# DESIGN REVIEW/CERTIFICATE OF APPROPRIATENESS APPLICATION

PROPERTY IN	NFORMATION				
Project/Property Add			Project Name/Bus				
230 Granvill	e St, Gaha	nna, OH 43230	Sheetz Lincoln (	Circle / Sheetz, Inc.			
Parcel #: 025-00	4250	Zoning: (see <u>Map</u> ) <b>CC</b>		Acreage: Proposed 1.25 AC			
	200	PLAN SPEC	CIFICATIONS				
Application Type: (check all that apply)	■ Site Plan	Landscaping	■ Building Design	n Demolition Other			
Project Description:							
be surrounded by pa	arking and drive		fuel center. The n	with fuel center. The primary building will ecessary utilities to serve the site such			
		APPLICANT II	NFORMATION				
Applicant Name (Primary Contact): D	.W. Routte		Applicant Address: 4270 Morse Road, Columbus, Ohio 43230				
Applicant E-mail: <b>Droutte@skilkengol</b>	d.com		Applicant Phone: 614-418-3100				
Business Name (if applicable): Skilk	en Gold Real Es	tate Development					
		ADDITIONA	L CONTACTS				
	*Ple	ease list all applicable co		ondence*

Zoning File No. DR-0478-2023

Kelly: Please see the responses below in red to each comment presented in the 3-22-2024 comments for the Sheetz Lincoln Circle project.

L-1

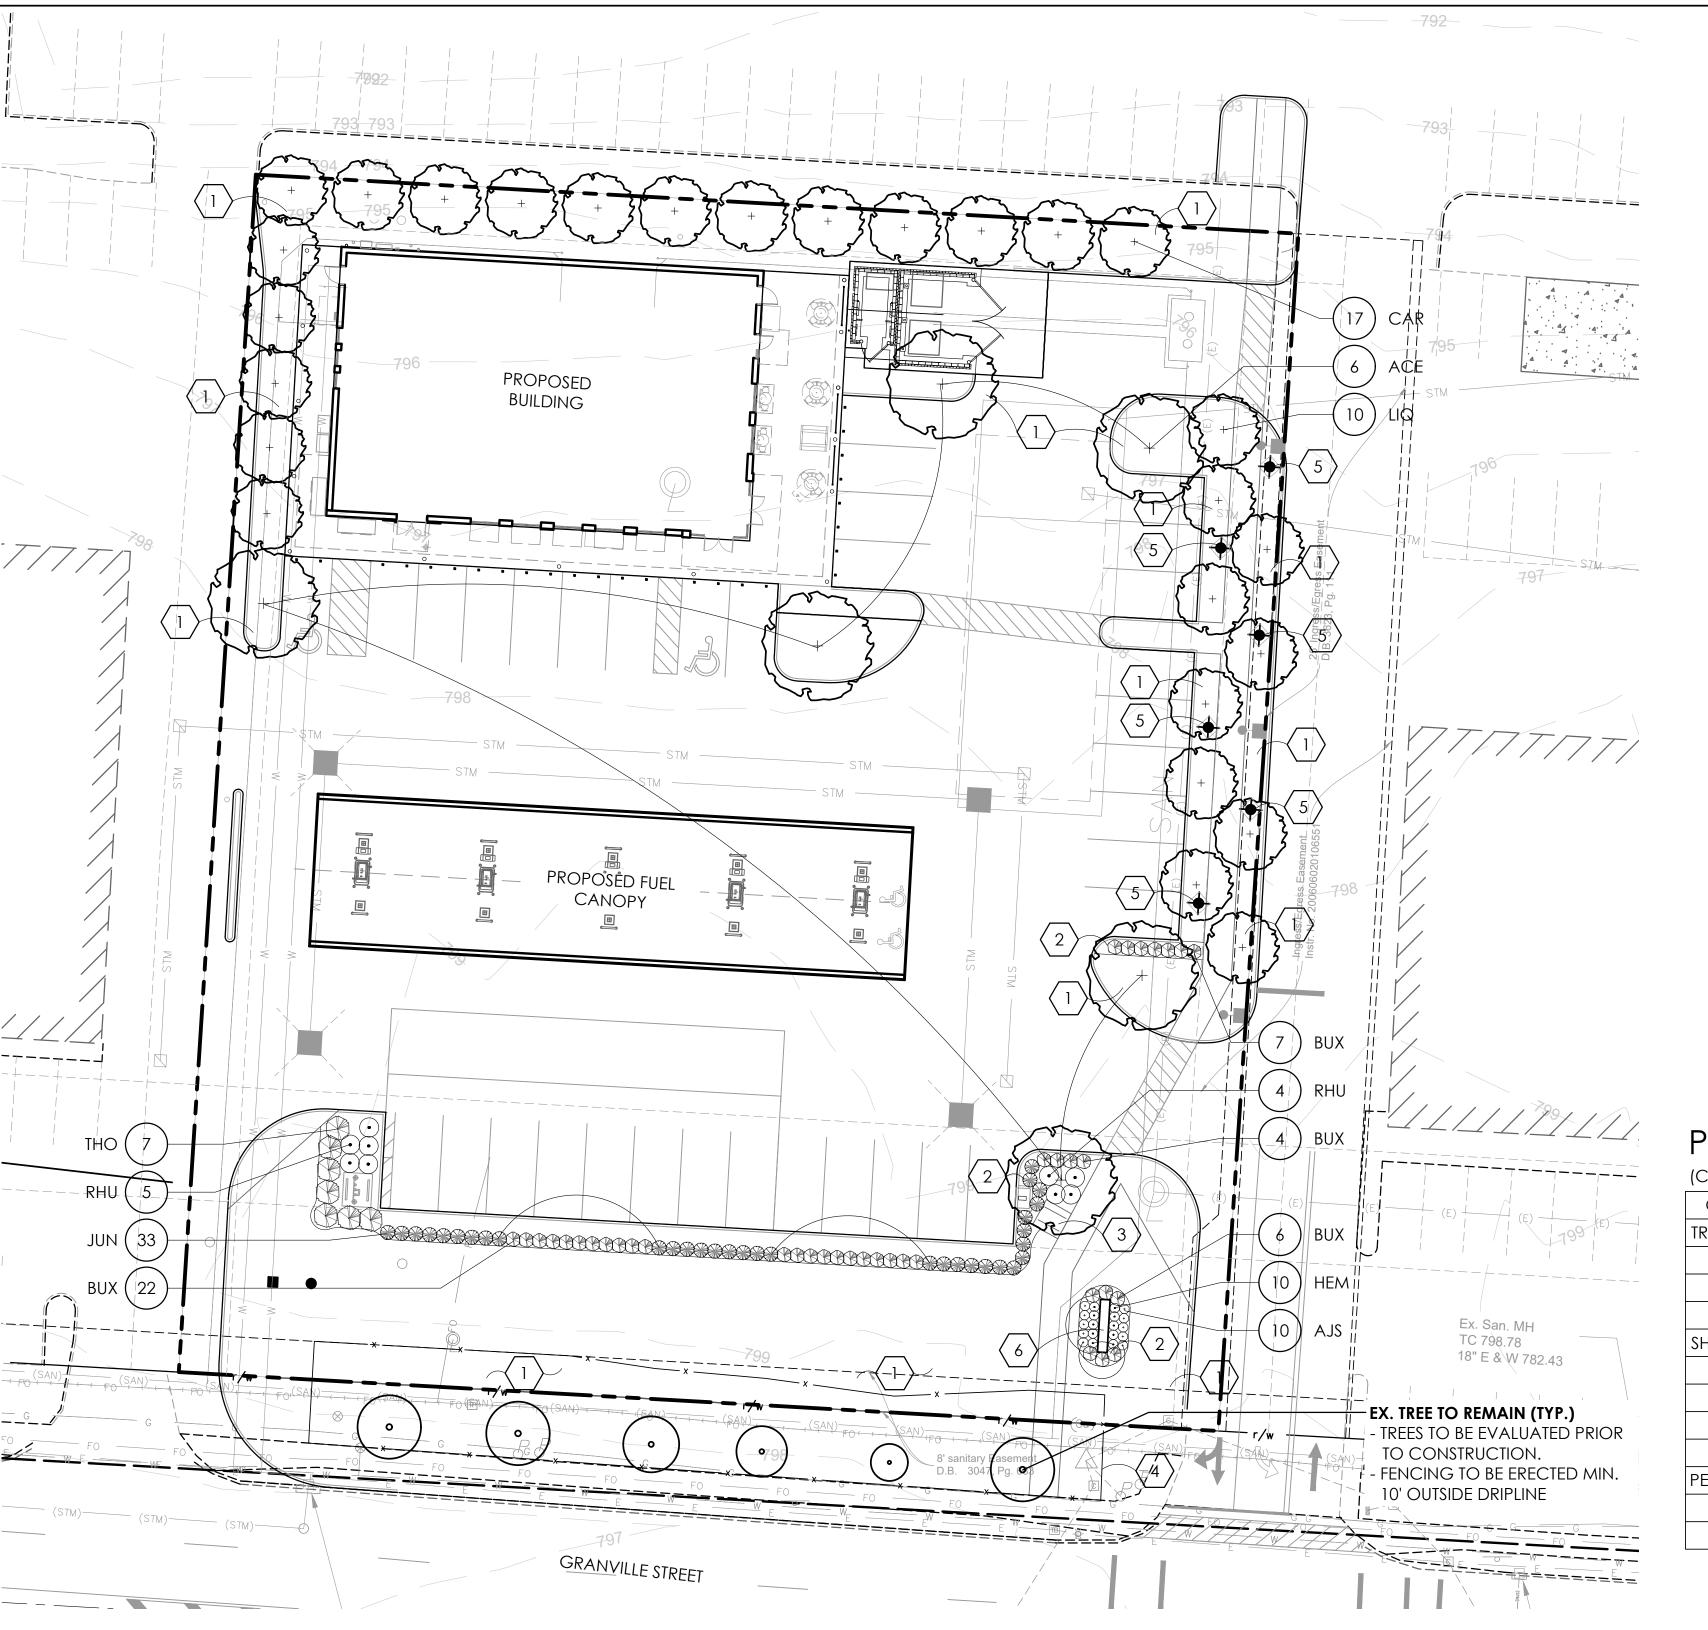
6. Landscape plans look appropriate. Based on imagery from November 2022, it appears that one of the 6 "street trees" near Granville St. may be dead. Ensure tree is in good condition before preserving. Any plant material to be preserved and counted for credit must be protected with tree protection fencing at least 10 feet past the dripline.

-Acknowledged, a note was added to account for this once full engineering takes place.

RL-9308-S1-R3

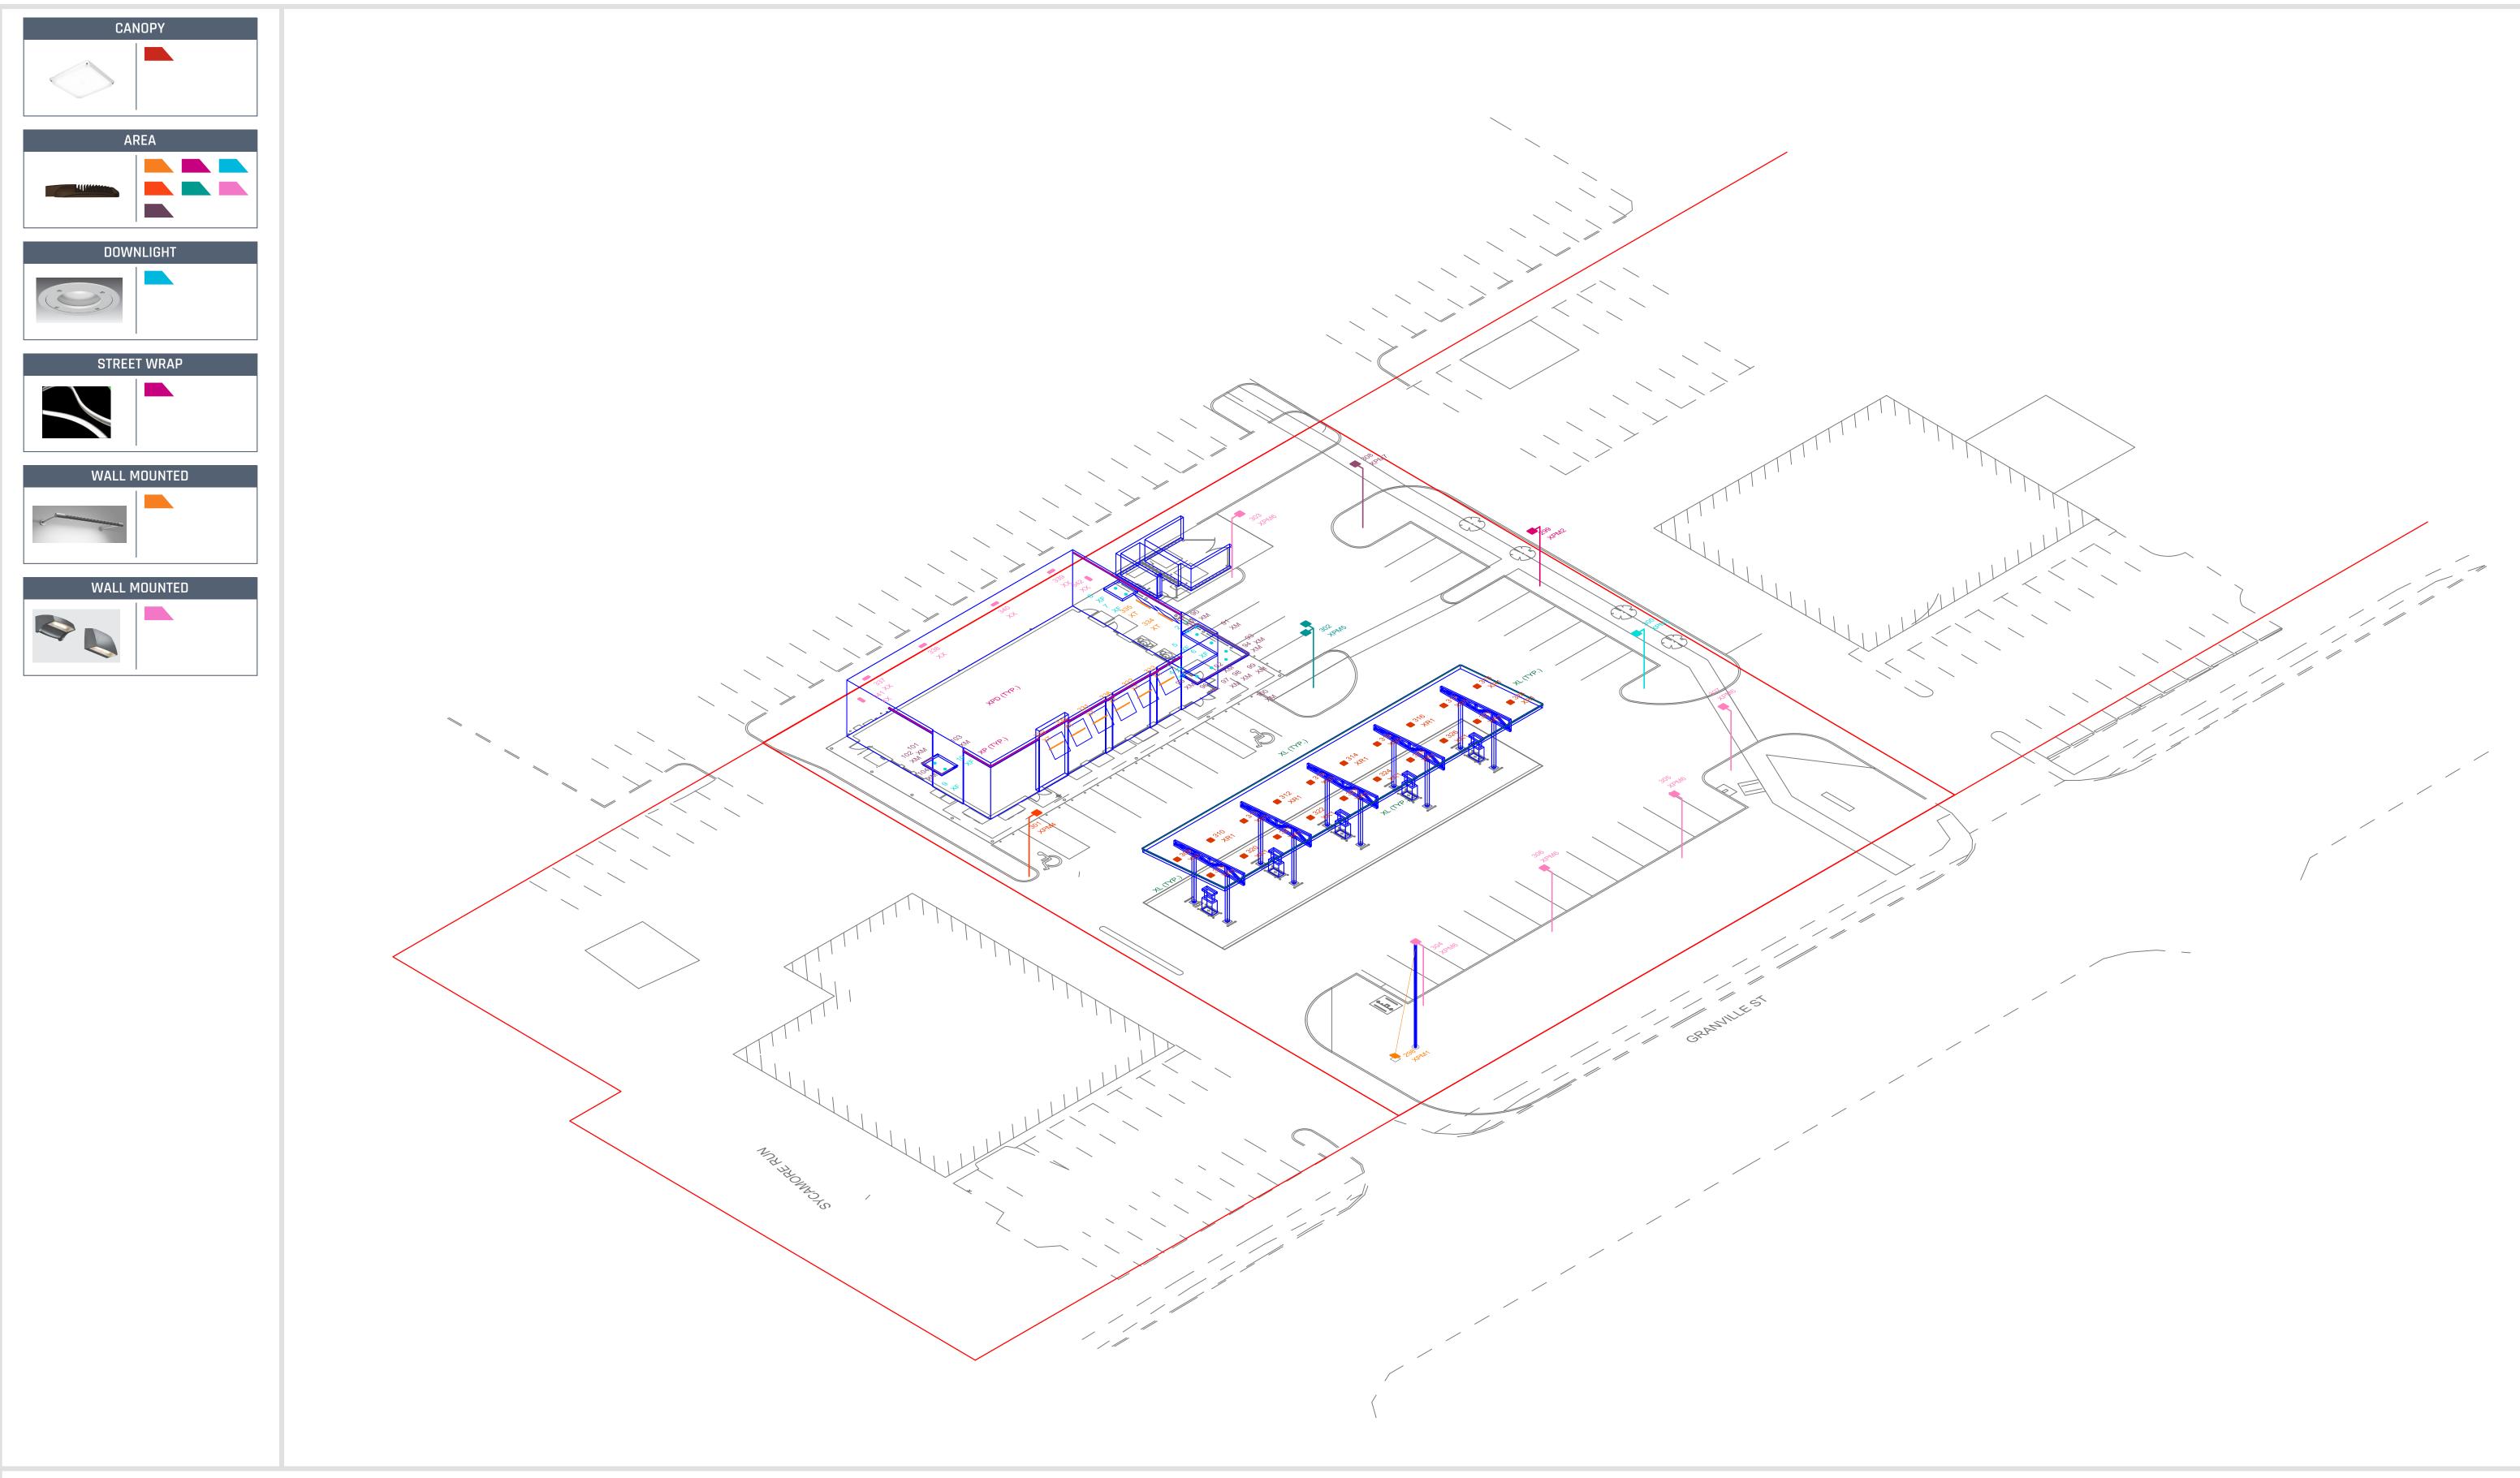
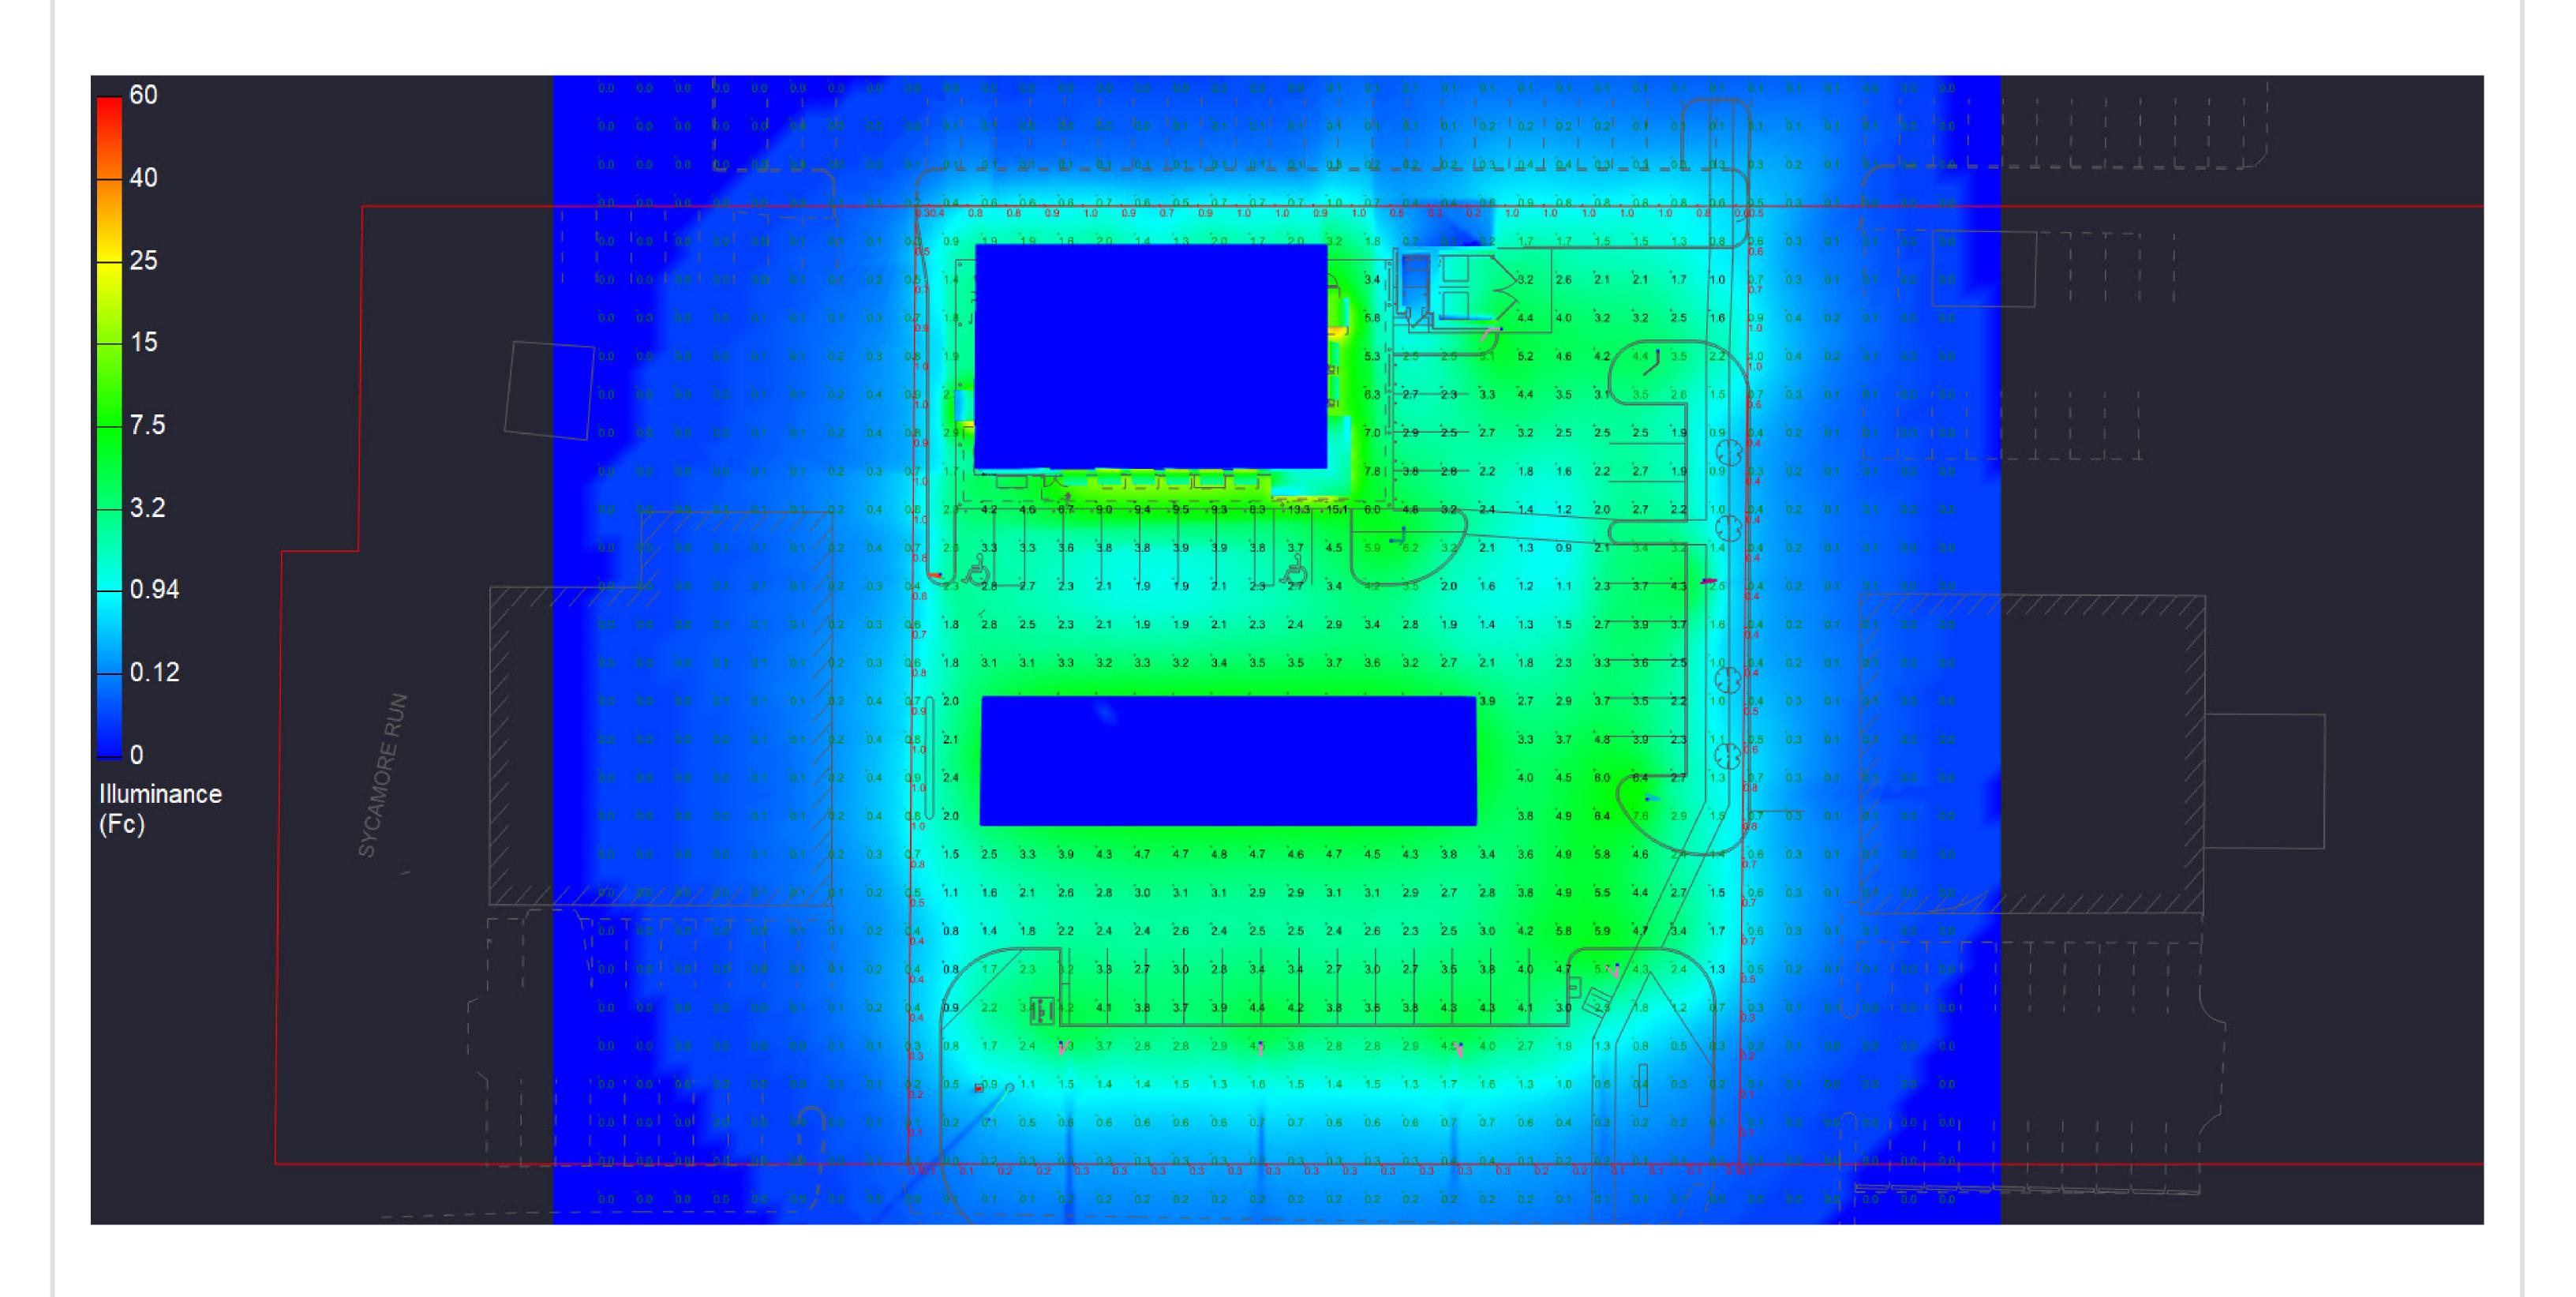
7. The submitted lighting plan is still not compliant with Code. Per Ch 1163.06(a), the foot candle value cannot exceed 1.0 fc at the property line. This is exceeded on the east property line. Please revise or apply for a variance.

-Revised per above comment.
